COLORADO DEPARTMENT OF TRANSPORTATION	Original NEPA	Reevaluation Date:	Project Code:
REEVALUATION FORM	Approval Date:		AQC R600-165
	1/19/2017	10/04/2019	Subaccount: 13599

Project Name and Location: Central 70 Project: Reevaluation #9, I-70 from Interstate 25 (I-25) to Quebec

NEPA Document Title: I-70 East ROD 1: Phase 1 (Central 70 Project), January 19, 2017

**Figure 3: Design Alteration Locations**

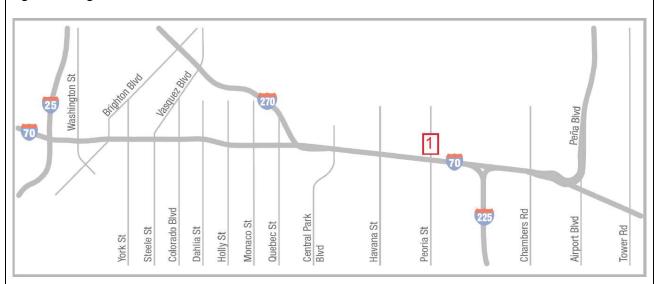
This reevaluation assesses the impacts from one design alteration. At Peoria Street, just to the north of I-70, the construction limits will be extended to allow the existing roadside drainage ditch to be re-graded to flow into the existing culvert and drainage system. See Figure 3 (below) for the location:

**Design Alteration:** In the pre-project condition storm water collects in the northeast quadrant of I-70 and Peoria Street and does not fully drain away into the storm water collection system. The City and County of Denver (CCD) has requested that this problem be corrected in conjunction with the other work that is currently being completed in the area. To solve this problem the existing drainage ditch on the east side of Peoria Street will be re-graded to the point where it connects to an existing culvert that carries the storm water to the west under Peoria Street. Also, the ditch on the west side of Peoria Street will be re-graded to carry the storm water away and into the existing drainage system.

To accomplish this, construction work will extend approximately 155 feet beyond the existing construction limits established by the Record of Decision (ROD). The construction limits extension is fully within the existing public Right-of-Way (ROW). See Attachment A for details.
